# ZONING BOARD OF APPEALS APPLICATION

## AREA VARIANCE

Street Address: 511 Carpenter Street Greenport, New York, 11944

AMENDED NOTICE OF DISAPPROVAL

1 3RD FLOOR PROPOSED  
1/4" = 1'-0"

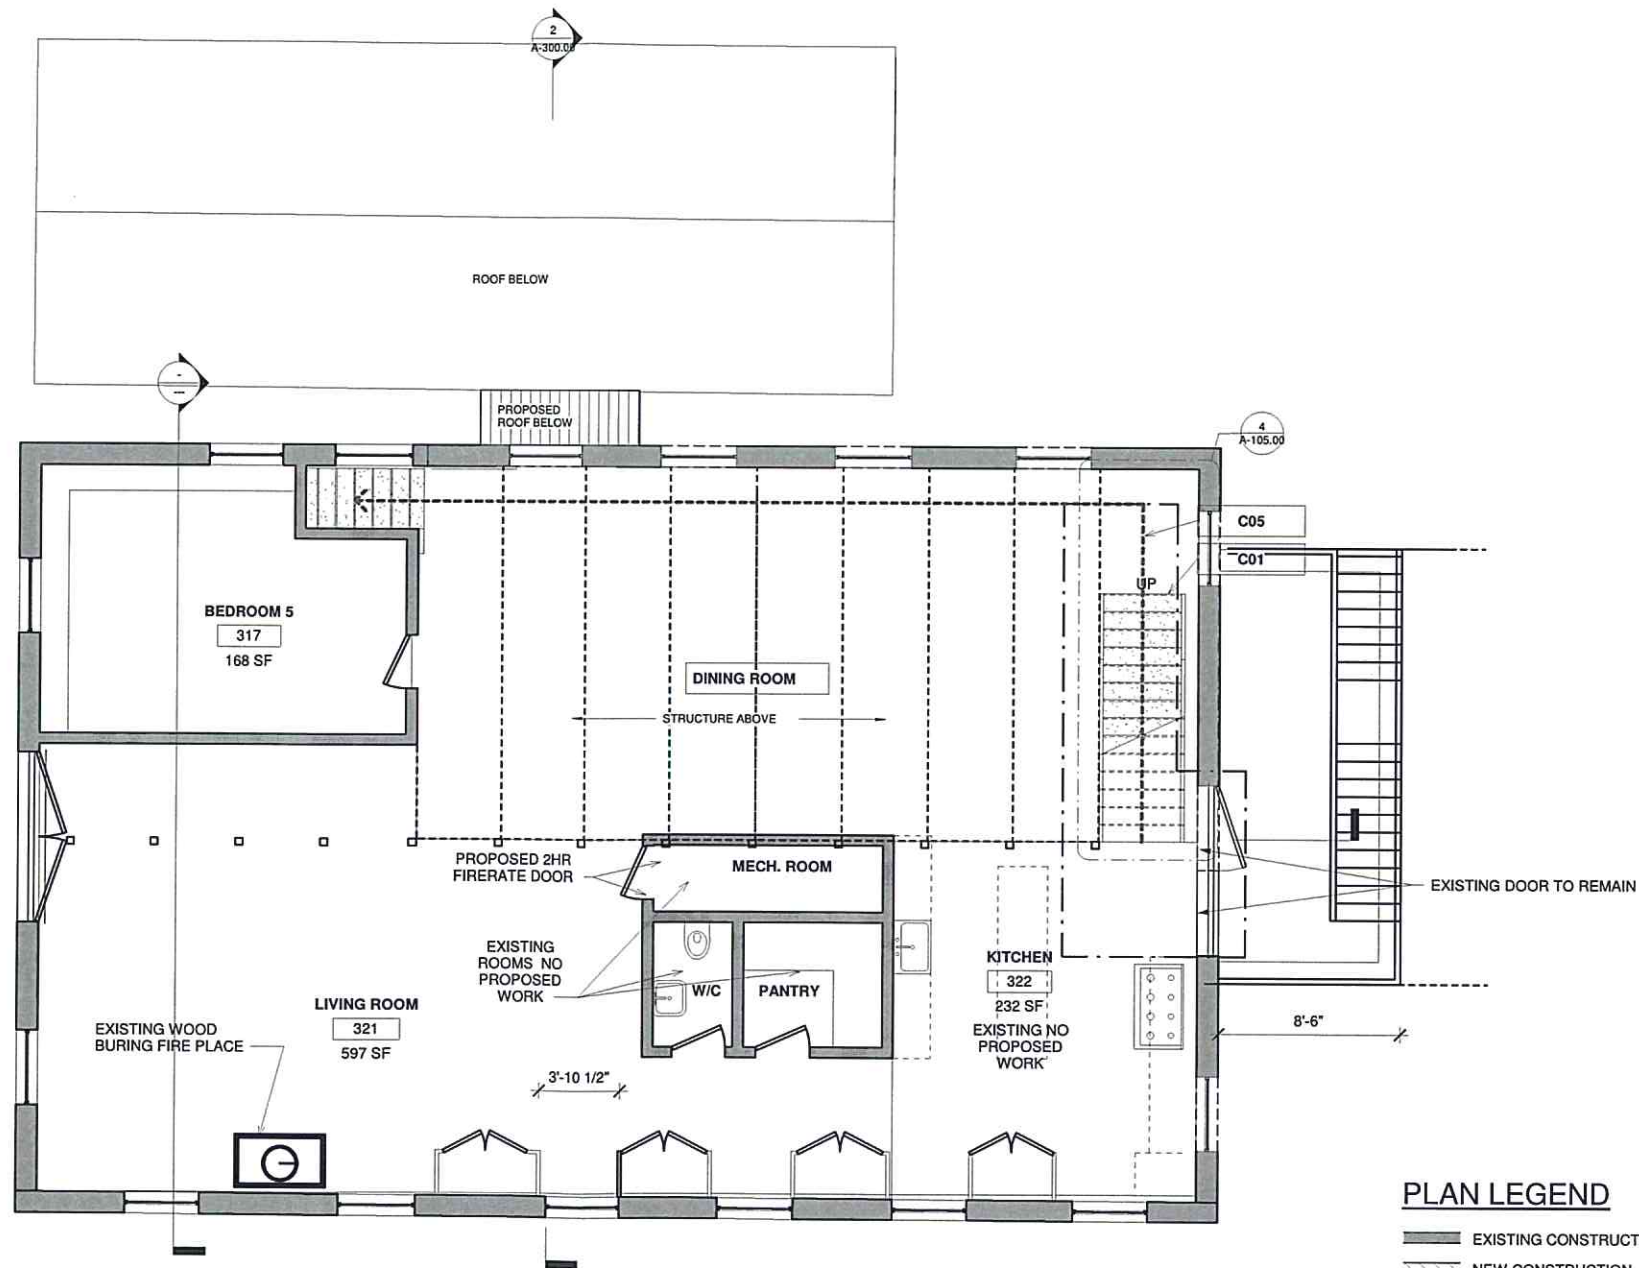
The plans show a proposed third floor addition. This would require an area variance for a third story.
